Subject: Issuance of Amendment No. 43 to Facility Operating License  
NPF-9 and Amendment No. 24 to Facility Operating License  
NPF-17 - McGuire Nuclear Station, Units 1 and 2

AMENDMENT TO FACILITY OPERATING LICENSE

ATTACHMENT TO LICENSE AMENDMENT NO. 43

SAFETY EVALUATION REPORT

FIGURE 2.1-1

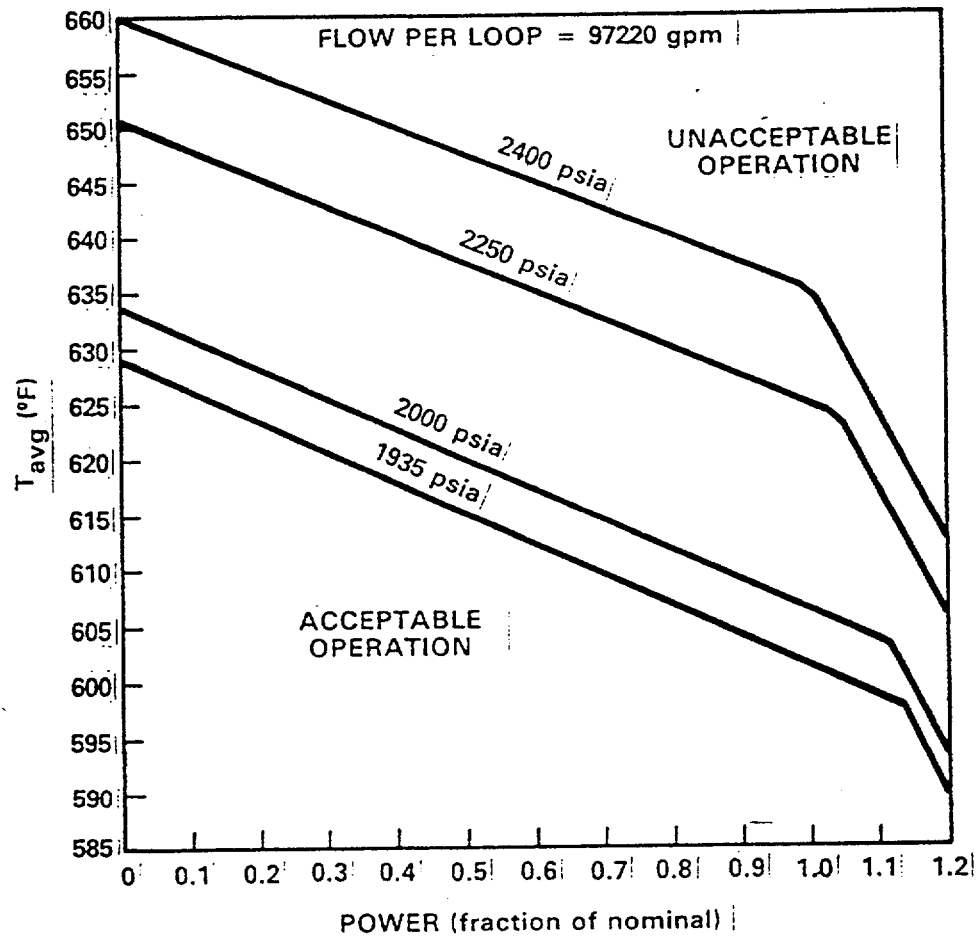
Figure 2.1-1a: The safety limits for DNB for Unit 1 have not further changed beyond the changes resulting from the use of OFA fuel and corresponding changes in analysis methodology discussed in Unit 1 Amendment 32 (Cycle 2), but the boiling limits are more restrictive because of the change in core flow reviewed and approved in the Unit 2 Cycle 2 Amendment.

FIGURE 3.2-2  
 $K(Z) - \text{NORMALIZED } F_Q(Z)$  AS A FUNCTION OF CORE HEIGHT

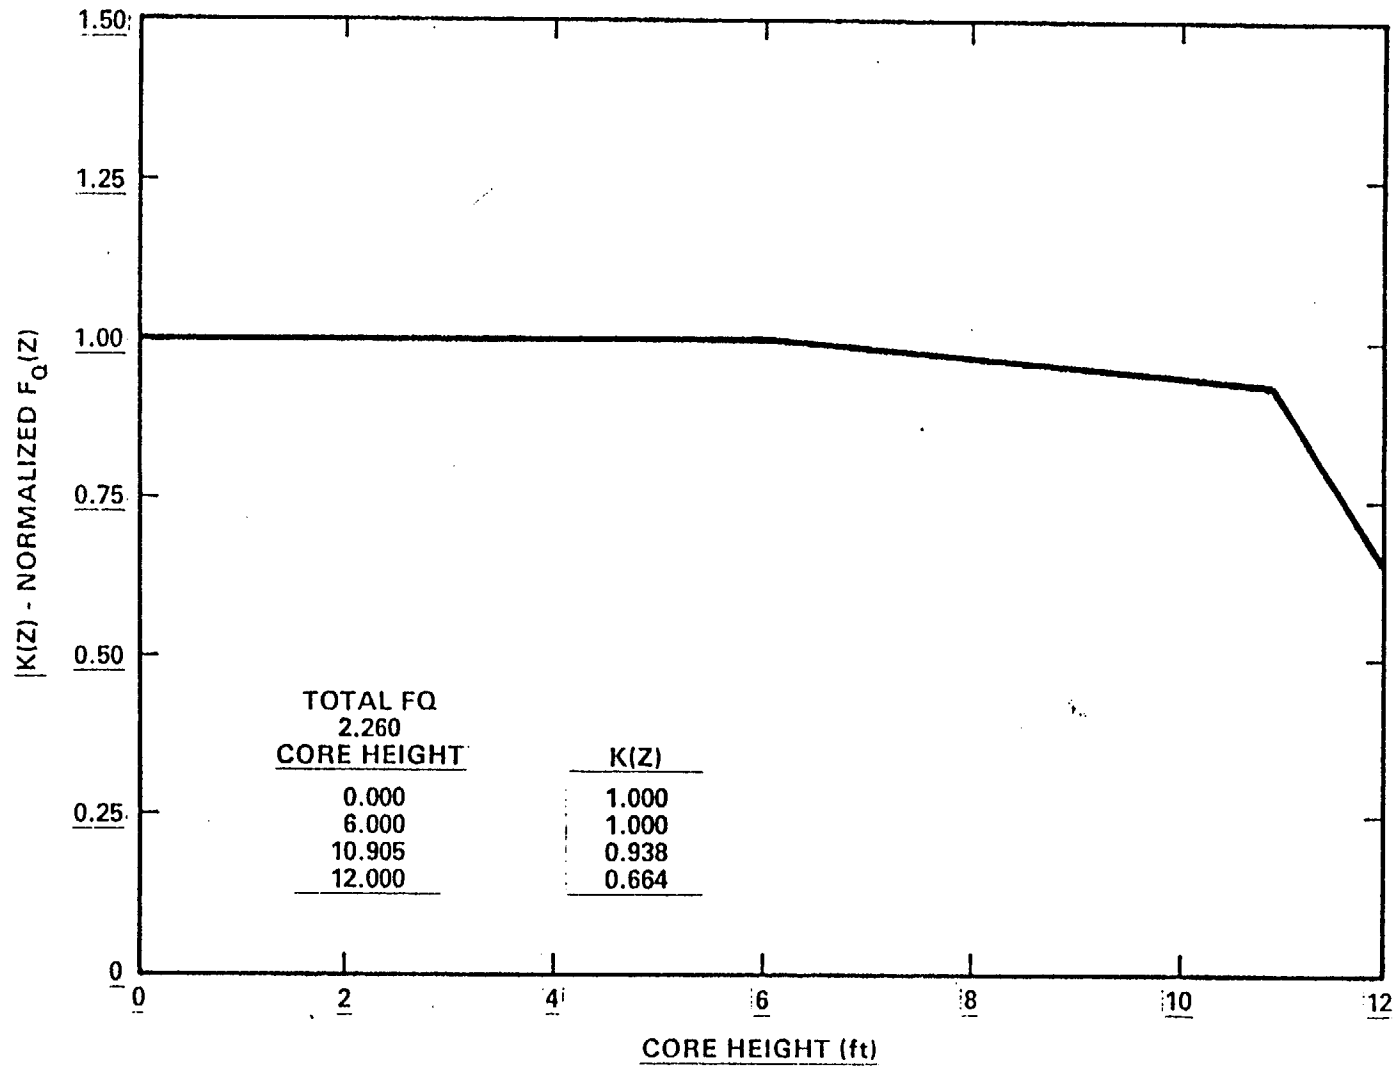
Section 3/4.2.1 and Bases, Section 3/4.2.2 and Figure 3.2-2a: The change in the target band for the axial flux difference is due to the change from CAOC to RAOC and Base Load Operation. The change to an  $F_0$  of 2.26 is approved as a result of the approval of the LOCA analysis using this value. The change to Figure 3.2-2a reflects the change to an  $F_0$  of 2.26 using approved Westinghouse methodology for determining  $K(Z)$  as a function of  $F_0$ .

Figure 3.2-3 RCS FLOW RATE VERSUS R - FOUR LOOPS IN OPERATION

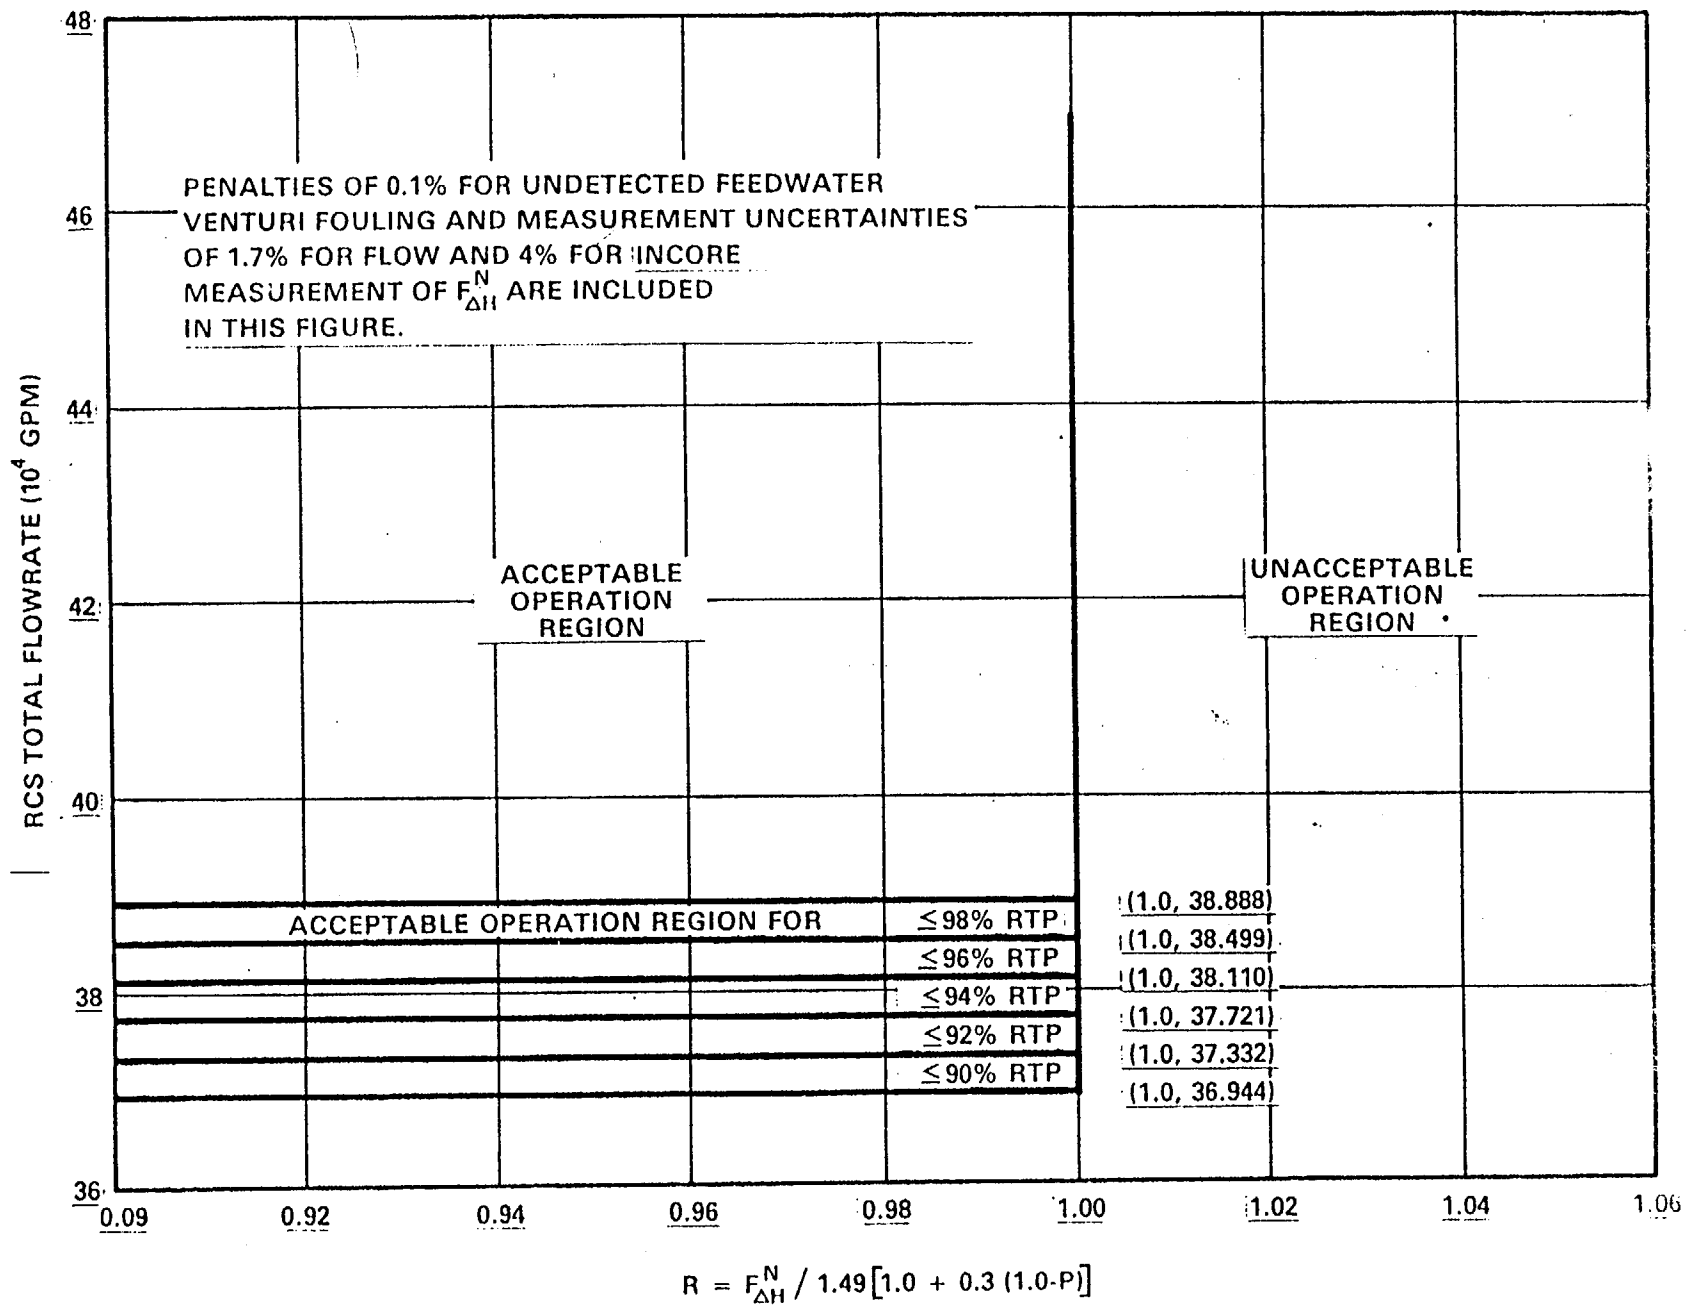
Figure 3.2-3a: The change reflects the elimination of the rod bow factor as in Unit 2 Cycle 2.
